PREPARED FOR THE PLAN COMMISSION

Project Address: 5817 Halley Way (3rd Alder District – Ald. Field)

Application Type: Planned Development (PD) Zoning Map Amendment and Conditional Use

Prepared By: Chris Wells, Planning Division
Report Includes Comments from other City Agencies, as noted

Image 1: 'Overall Second Floor'. Left: 2022 Approval; Right: Current Proposal

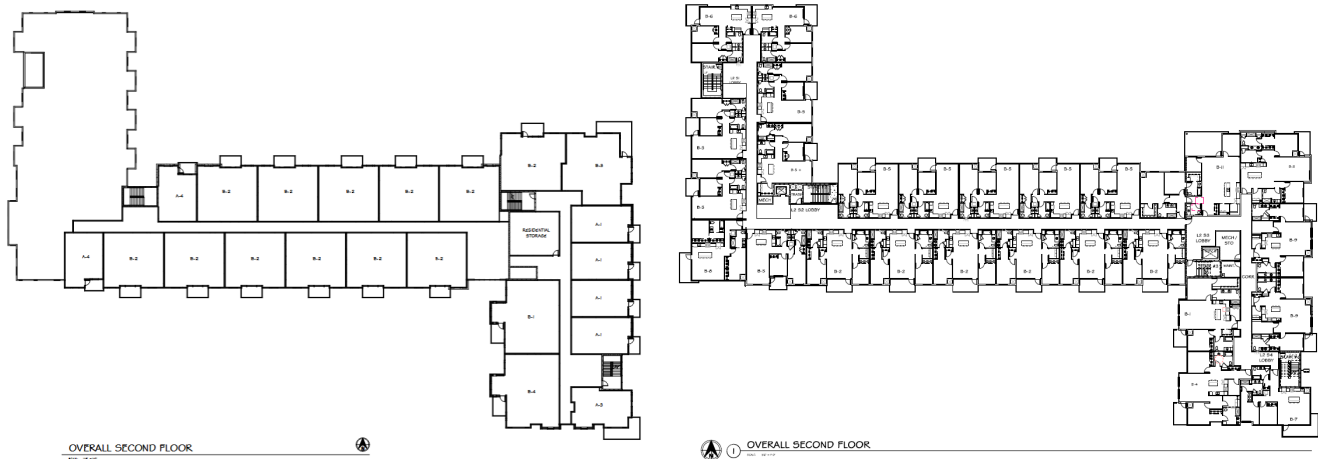
As a result of the shift to nearly all two-bedroom units, while the footprint is essentially unchanged, the building's massing has increased. As can be seen in Images 1 and 2 below, the second floor now extends across the entire building footprint and the third floor covers roughly 80 percent, up from roughly 45 percent with the 2022 approval.

Image 2: 'Overall Third Floor'. Left: 2022 Approval; Right: Current Proposal

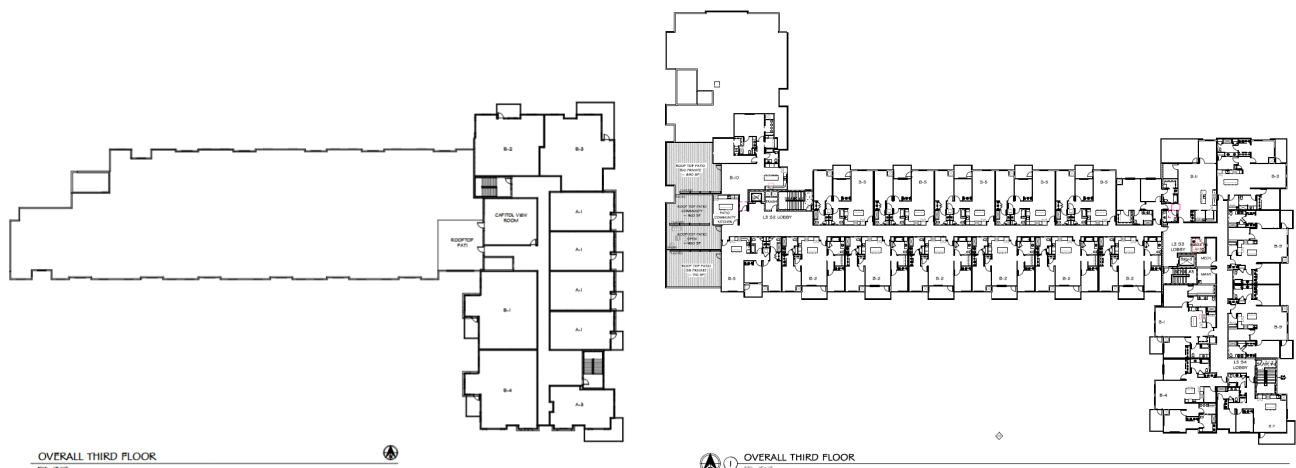
As a result of the increased floorplates of the two upper floors, the overall building height, most notably as viewed from the north, south and west, is one story taller in most areas.
